This document transmits the Initial Issue of Service Bulletin EV2500-71-0278

**V2500-ENG-71-0278**

POWER PLANT – CORE HARNESSSES – INTRODUCTION OF EEC LOOMS G AND H WITH REVISED  
INSULATION SHIELDING

**Figure 1**  
**Fire Detection Harness – EEC Looms G and H Insulation Shielding**  
**Before and After Alteration**

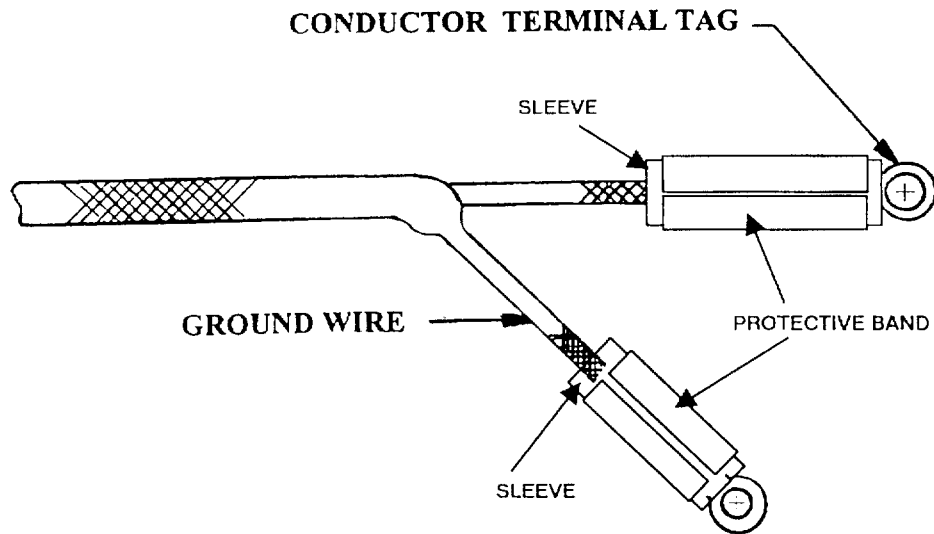
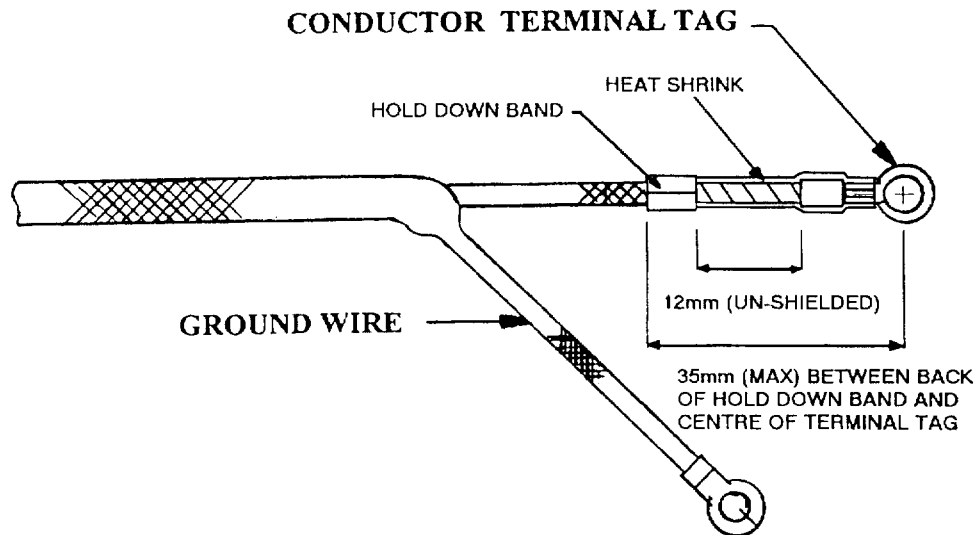
(1) The changes introduced are (Refer to Figure 1) :-

(a) Revised Fire Detection Harnesses, EEC Looms G and H, are introduced similar to the existing items except for the following:-

- (i) There are two locations on the harness with terminal tags and ground wires arranged as shown in Fig.1. At one of these locations only layers of glass tape are introduced between the existing insulation and the inner wire braid, with the unshielded space being increased from 0.25in. to 0.47in. (6,35mm to 12,00mm.)
- (ii) The protective bands have been reduced in quantity from 4 off to 2 off per harness.
- (iii) The Sleeves have been reduced in quantity from 8 off to 4 off per harness.
- (iv) Existing insulation shields are replaced by heat shrink sleeving.
